Modification to run CPU09CMI on 3MHz bus.

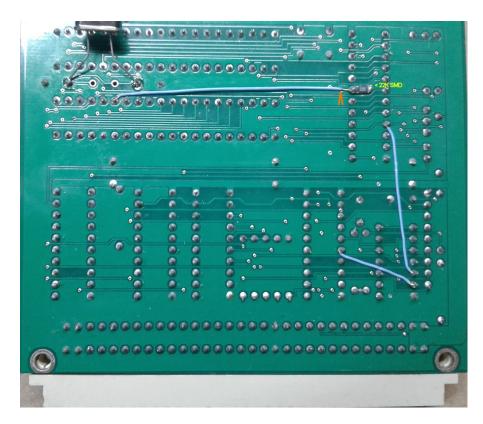
Replace xtal into 12MHz Replace GAL CMI_1 by CMI-4_1 Use the HD63C09 or MC68B02 with full modification.

On solder side:

Cut trace between U13-19 and via (OVMA) Place 22K resistor between U13-19 and Gnd

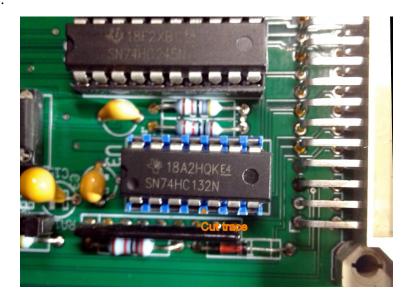
To keep CPUxxCMI 6802 compatible:

On top side:

Cut trace between U3-4 and U3-5

On solder side:

Place wire from U3-5 to U13-9 Place wire from U3-6 to U4-6
